Re: ZBA #01-20
Residences on the Charles
15 Riverdale Avenue
Newton, MA

We are in receipt of the Planning Department's Public Hearing Memorandum dated March 26, 2020 and the Horsley Witten Group Peer Review dated March 25, 2020 issued for the proposed Residences on the Charles. We appreciate the time and effort of the Planning Department Staff and the Horsley Witten Group. Both documents contained a very detailed review of the project submissions and included numerous comments. On behalf of CPC Land Acquisition Company, LLC ("Applicant"), a wholly owned subsidiary of Criterion Development Partners, we have prepared this letter to respond to all comments and requests for additional information. The format of the following sections is as follows: comments excerpted directly from the review documents are included in italic font with comments from the Planning Staff prefaced by "P" and a numerical designation and comments from Horsley Witten Group prefaced by "HW" and a numerical designation. The Applicant's responses are provided in bold font and are prefaced by "R" and the applicable numerical designation.

Figure 1 Original Bridge Elevation

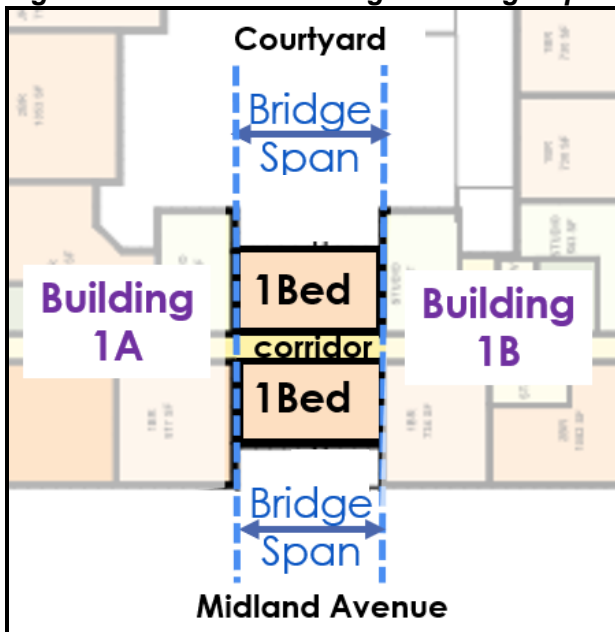
- P-4:** *“A key focal point and unique design feature of the project is the bridge that connects the two wings of Building 1. The bridge has been revised to be enlarged and lit, however, Planning Staff thinks there is more that could be done to further enhance the bridge as a focal point and visual connection to the Charles River. Planning Staff has concerns regarding the bridge acting as a visual barrier to the courtyard due to the units that are located within the bridge, and that the bridge is four stories in height. Planning suggests the applicant consider removing the residential units located within the bridge, or removing the bridge at lower floors and only connect at a higher floor to achieve visual transparency.”*

- R-4:** **We appreciate Planning Staff’s comments and wish to explain how the bridge was originally designed and how that design has evolved to address concerns regarding aesthetics, massing and sight lines.**

After an initial evaluation of the project site’s context, the design team determined that the massing of Building 1 would be built around the creation of a new visual and physical connection between the neighborhood and the riverfront. A bridge element was used to connect the wings of Building 1 rather than create separate buildings as the latter would require redundant features such as lobbies, elevators and stairs be provided in both buildings. To reflect the historic context of the area, design cues for the proposed bridge were taken from the connecting elements of mill buildings located along the Charles River. As originally proposed, the bridge was a 4-story structure with a glass-sided pedestrian bridge connecting Buildings 1A and 1B on the second floor. The residential portion of the bridge on floors 3 through 5 consisted of an internal corridor flanked on either side by a one-bedroom unit. The original bridge elevation and floor plans are shown in Figures 1 and 2, respectively.

Figure 8 Detail of Parking at Building 1B

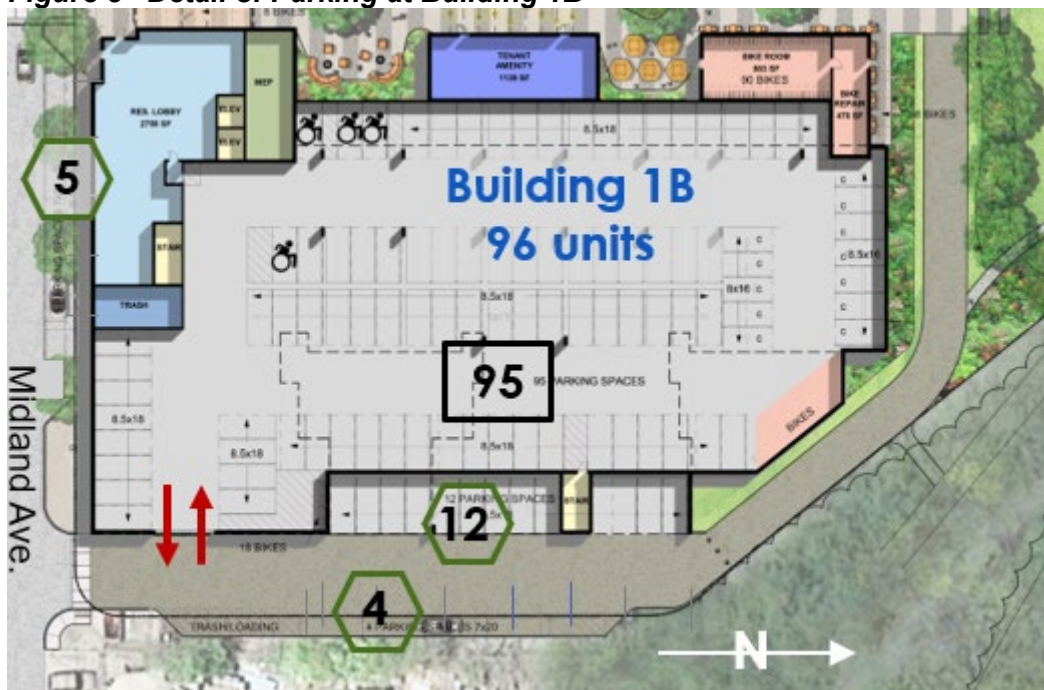
P-22: *“The east wing of Building 1 features 95 parking stalls, a combination of open air and covered parking with four covered accessible stalls. As requested above, the Planning Department requests a more detailed eastern elevation of the eastern wing of Building 1. There are 12 compact parking stalls, five measure 8 feet by 16 feet and seven measure 8.5 feet by 16 feet. Where Riverdale Avenue breaks from Midland Avenue and extends*

along the eastern elevation of the east wing of Building 1, are an additional 12 stalls, eight of which are covered and four of which are open air, directly across from that are four parallel surface level stalls that measure nine feet by 21 feet.

R-22: The Applicant apologizes for any confusion regarding the location of the proposed parking stalls. Below is a graphic showing the parking configuration at the easterly side of easterly wing of Building 1. This wing is referred to as Building 1B. The parking includes: 95 parking spaces within the podium parking garage and accessed by a garage door; 12 perpendicular spaces exterior to the garage but covered by upper stories of Building 1B that are accessible from an exterior drive aisle; and 4 exterior parallel parking spaces that are accessible from the same exterior drive aisle. A more detailed parking discussion, including parking space dimensions, is included in the Appendix.

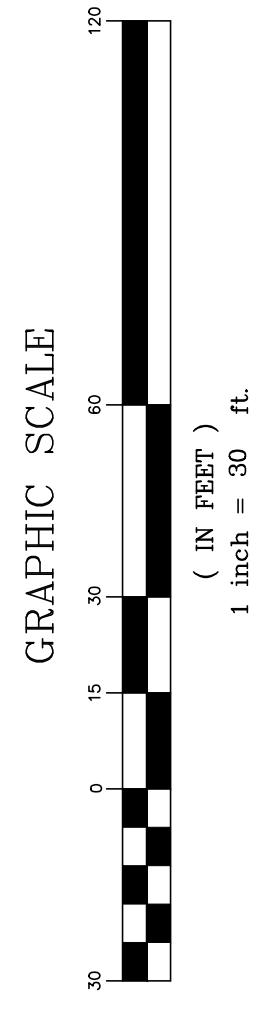
P-34: "Planning Staff would like more information on the expected capacity of the proposed snow storage."

- HW-9: "It appears that the Snow Storage Plan (Sheet C-109) indicates snow storage areas near the porous pavement areas. Snow melt that is packed full of sediment can eventually lead to clogging of the porous pavement. HW recommends that the Applicant consider adjusting the snow storage plans in light of the maintenance considerations for porous pavement areas."*

- R-9: Snow storage areas along the porous pavement within the BLSF have been removed from the plan and limited to more appropriate areas of the site. Details regarding the proposed snow storage and removal methods are provided in the Appendix as well as in the revised plans. The area shown adjacent to the porous pavement will be a reinforced turf surface and minimal sediment is anticipated to be generated here. Also, the porous pavement shall reduce the required salt needed for winter maintenance.**
